**Bradley Villa Farm, Huddersfield
Proposed Residential Development
Transport Assessment Addendum**

October 2021 (Initial Issue)

Prepared on behalf of
Redrow Homes (Yorkshire) Ltd, R Kershaw & S Gill

Image 2.1 Proposed BVF Phase Bradford Road/Site Access (with Signalised Pedestrian Crossing)

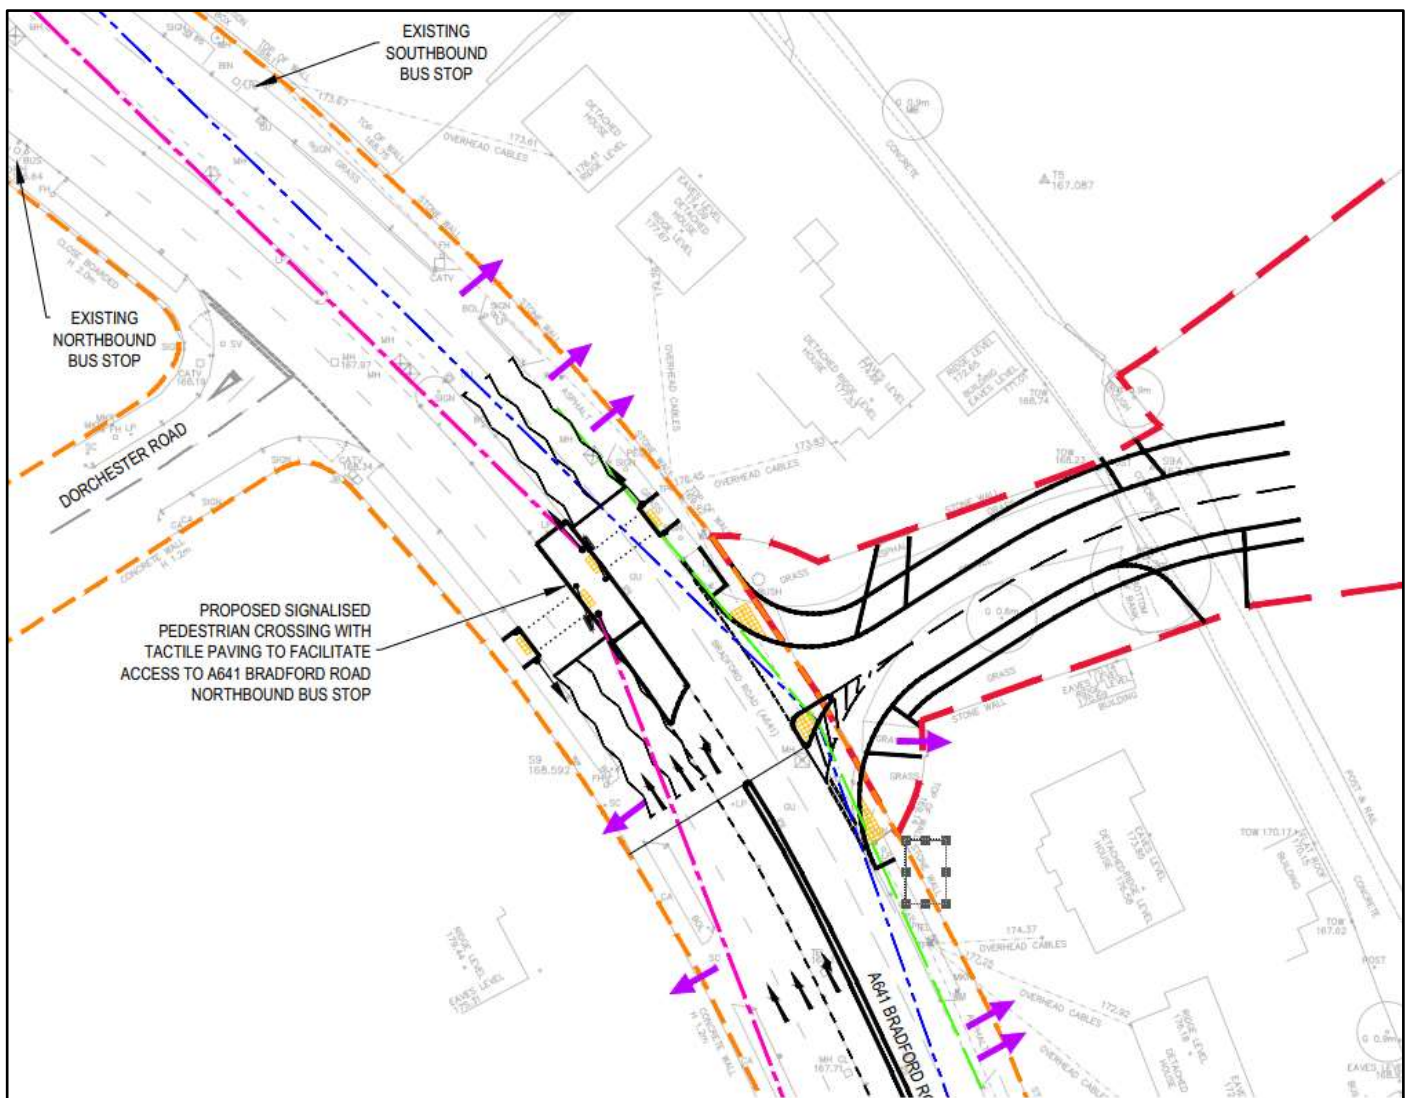
2.2.2 In order for residents of the development Site to satisfactorily access both existing bus stops on Bradford Road the original layout included a staggered, uncontrolled pedestrian crossing (comprising dropped kerbing and tactile paving) between the Site Access and Dorchester Road. In their consultation response the Council raise concerns regarding the provision of an uncontrolled facility and request that *“the application team explores the provision of a signal-controlled pedestrian crossing at a suitable location that facilitates a pedestrian desire line between the site access and the north-bound Bradford Road bus stop”*.

2.2.5 In their consultation response Kirklees Council state that they require the proposed Bradford Road/Site Access arrangements (as shown on the drawing in Appendix C) to be secured by a suitable planning condition, alongside a further planning condition requiring a full Road Safety Audit (Stages 1 to 4) as the layout progresses to detailed design and construction. This is a standard requirement and is acceptable.

2.2.3 Such a scheme has therefore been explored/designed and a staggered signalised pedestrian crossing is proposed to be provided on Bradford Road between the Site Access and Dorchester Road – as shown on the drawing in Appendix C and the extract in Image 2.1. The location of the crossing facilitates the pedestrian desire line between the northbound bus stop and the Site Access as well as ensuring there is satisfactory visibility of the signalised stoplines for vehicles emerging from Dorchester Road as well as for vehicles travelling northbound and southbound along Bradford Road.

2.2.4 The proposed crossing facilities will also benefit existing pedestrian trips to bus stops, local shops, schools etc.

Image 2.2 Proposed BVF Phase Emergency/Ped/Cycle Link to Bradley Road

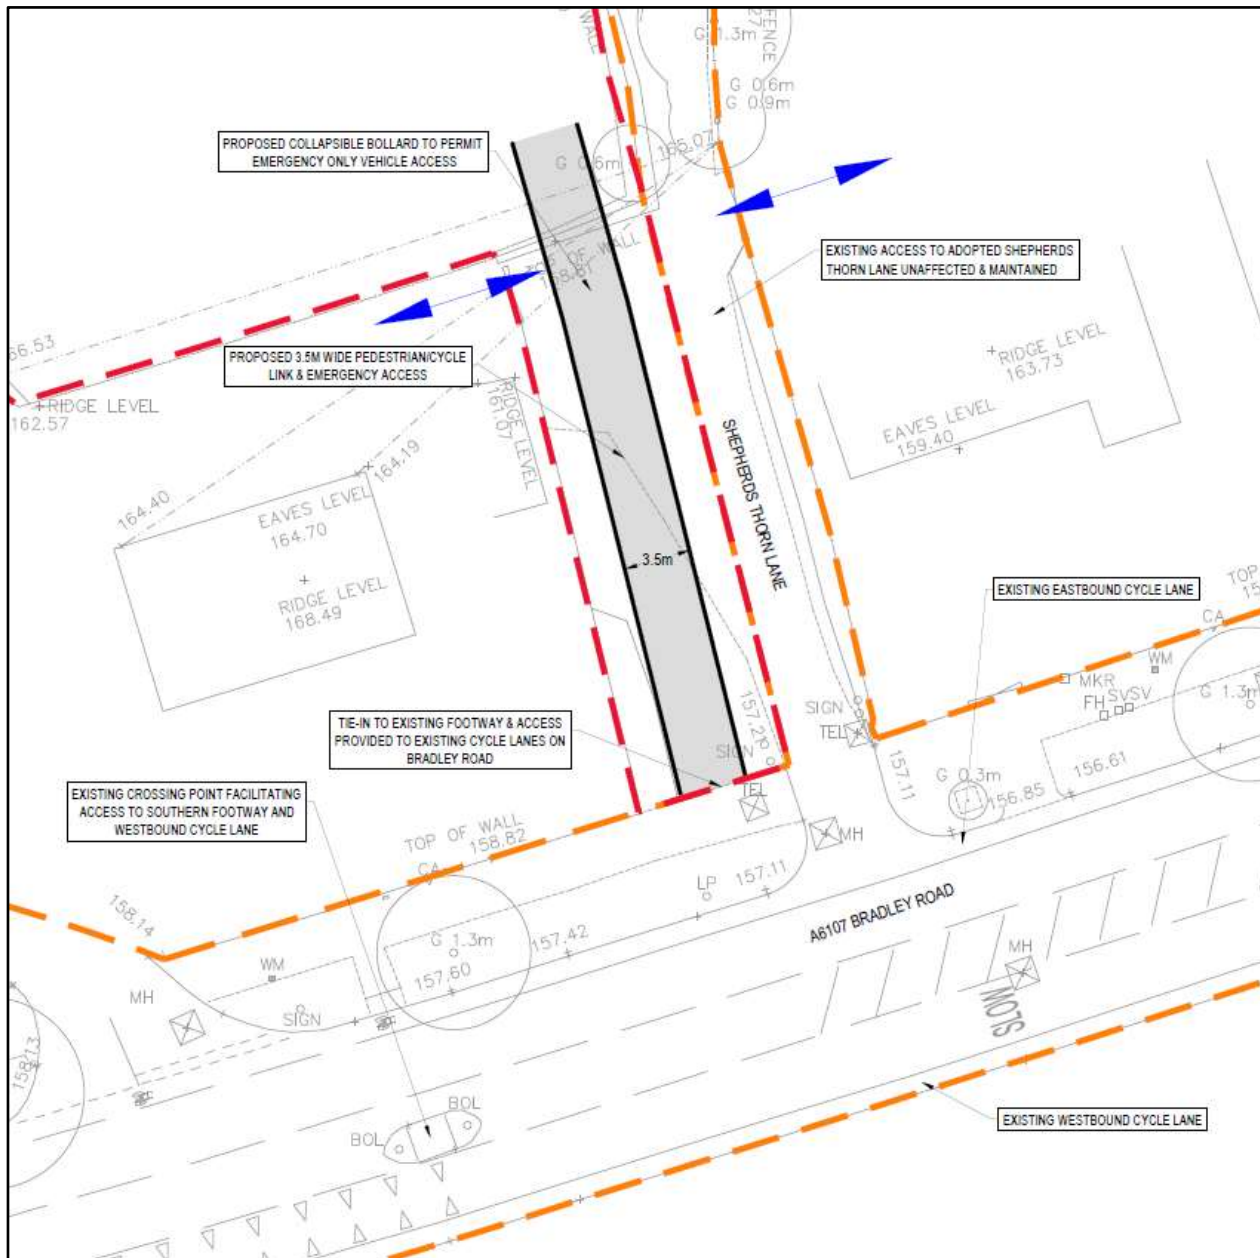
2.2.9 In their consultation response the Council accepts the provision of the proposed emergency access via Shepherds Thorn Lane and requests that this is secured by a suitable planning condition which refers to the drawing in Appendix D.

2.2.7 Notwithstanding this it is proposed to provide an alternative emergency access which connects to Bradley Road via the existing Shepherds Thorn Lane corridor. A suggested layout for the proposed 3.5m wide emergency access, which also provides a pedestrian/cycle link, is shown on the drawing in Appendix D, as well as on Image 2.1.

2.2.8 The suggested alignment of the link connection to Bradley Road is indicated within the existing green verge but alternatively, in order to reduce the impact on this verge, it may be possible for the link to utilise the initial section of the surfaced Shepherds Thorn Lane which is an adopted highway - this is a matter for detailed design.

Image 3.1 M62 Junction 25 (Lower Level Roundabout) – Existing Layout

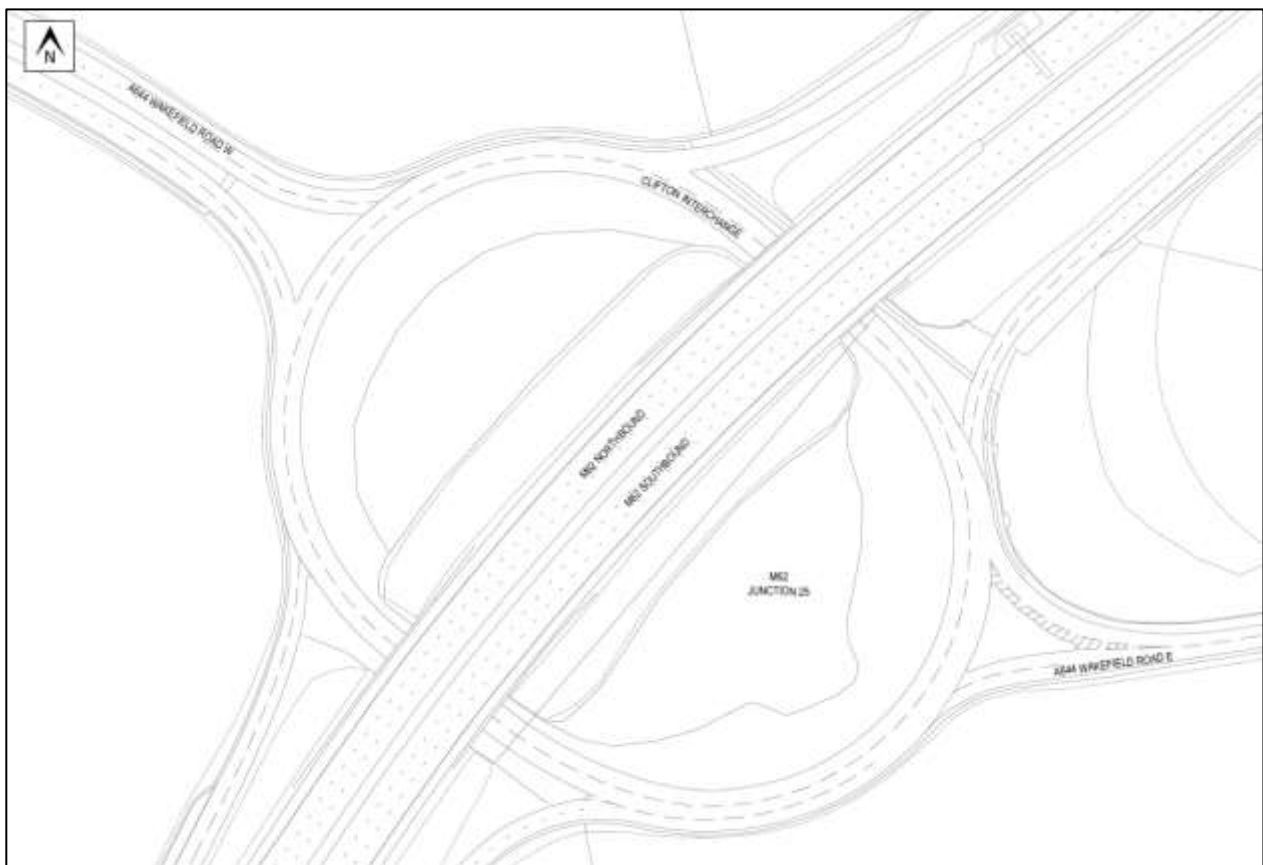
3.5.1 HE/JSJV have queried in their consultation whether or not the modelling of Junction 25 incorporates the committed highway improvements secured as part of the Clifton Business Park planning consent.

3.5.4 Notwithstanding any of the above reasons, whether the effect of Cooper Bridge is modelled or not is irrelevant to the outcome of the assessment work because the impact of the proposed BVF (Redrow) Phase of development on J25 is negligible - both in terms of overall development trips (maximum of 37 trips in the peak hour i.e. just one extra vehicle every 1.6 minutes on average) and in terms of material impact (just a 1.05% to 1.17% increase in flows compared to baseline traffic).

PROJECT	BRADLEY VILLA, HUDDERSFIELD
DRAWING TITLE	A641 BRADFORD ROAD PROPOSED SITE ACCESS ARRANGEMENT

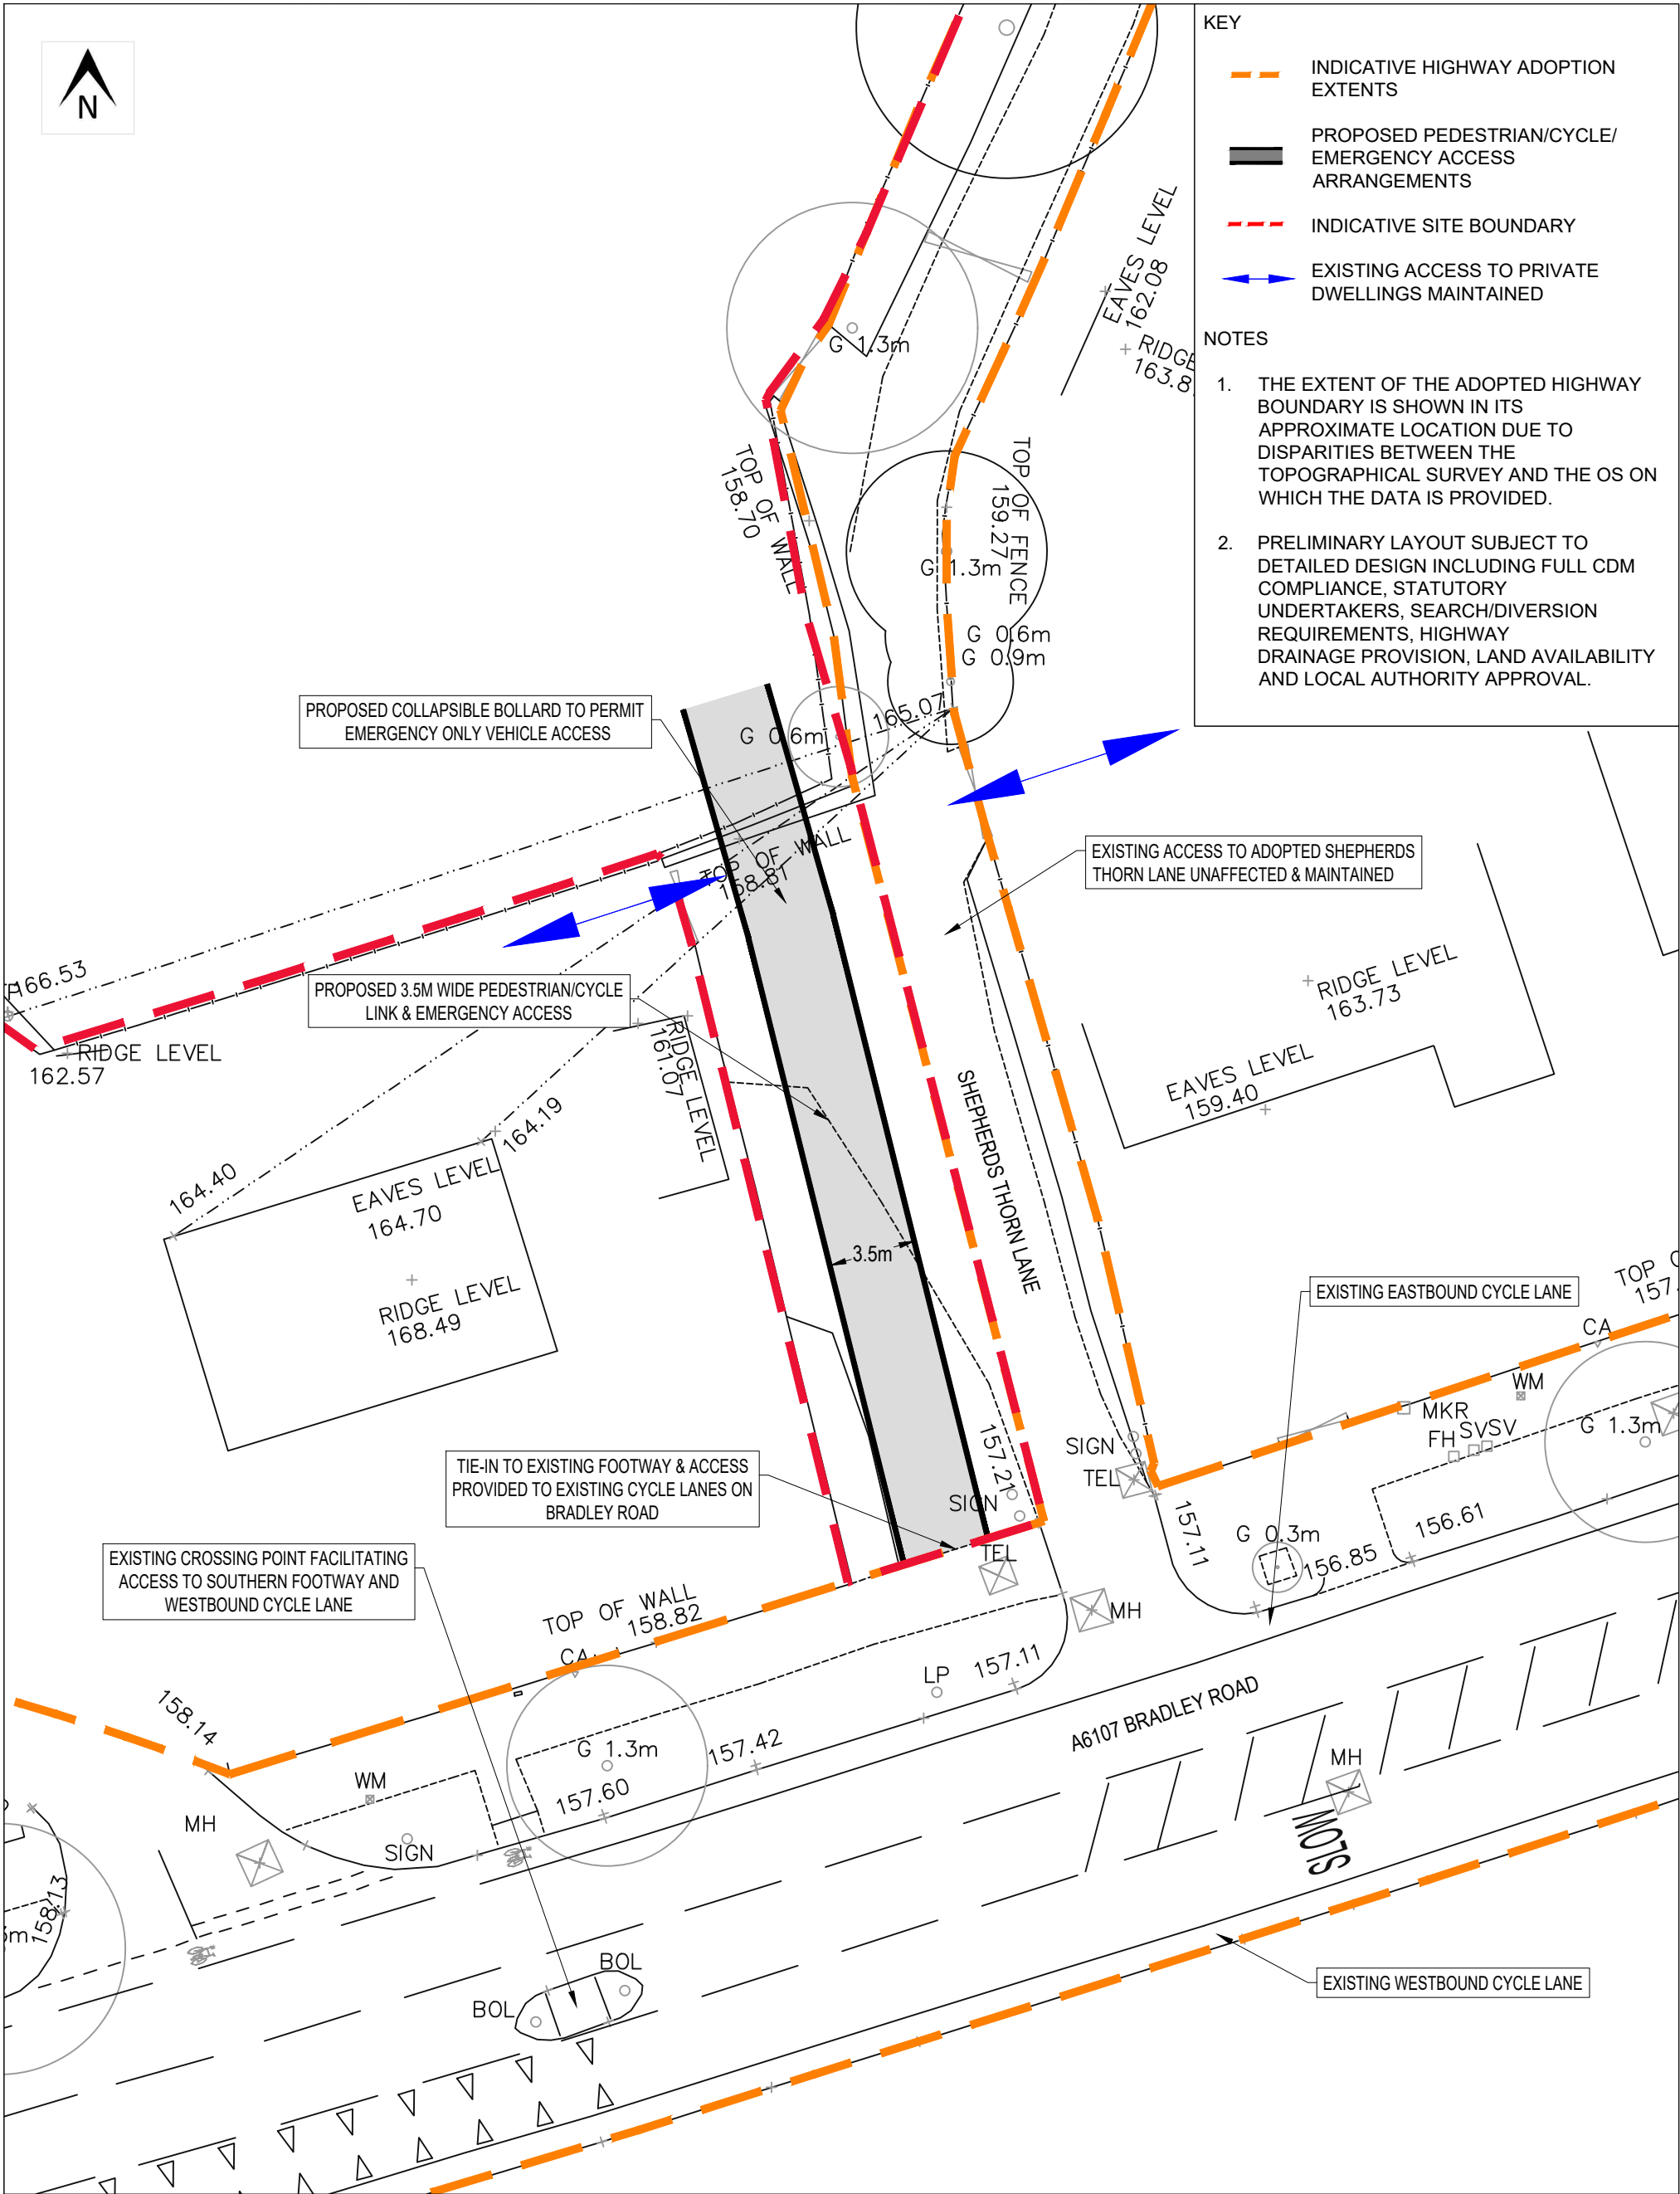
This should be subject to a full Road Safety Audit (Stages 1-4) and would form a future Section 278 Application/Agreement for off-site highways works. The submitted drawing should be secured by an appropriate planning condition, as should the Stage 1-4 Road Safety Audit. This is discussed in more detail, later.

Pedestrian/cycle access would be provided from the proposed vehicular junction onto the A641 Bradford Road. This junction also provides uncontrolled pedestrian crossing facilities across the arm of the Site Access in the form of a central refuge island, dropped crossings and tactile paving – (presented on a drawing in TA Appendix H).

REV	DATE	BY	DESCRIPTION	CHK	APP
C	11/10/21	CJF	BRADFORD RD SIGNAL CROSSING ADDED	PMO	PMO
B	18/01/21	JS	EXTENDED TOPO SURVEY ADDED	PMO	PMO
A	07/09/20	JS	HGV TRACKING ADDED	PMO	PMO
-	26/08/20	JS	INITIAL ISSUE	PMO	PMO
STATUS			PRELIMINARY
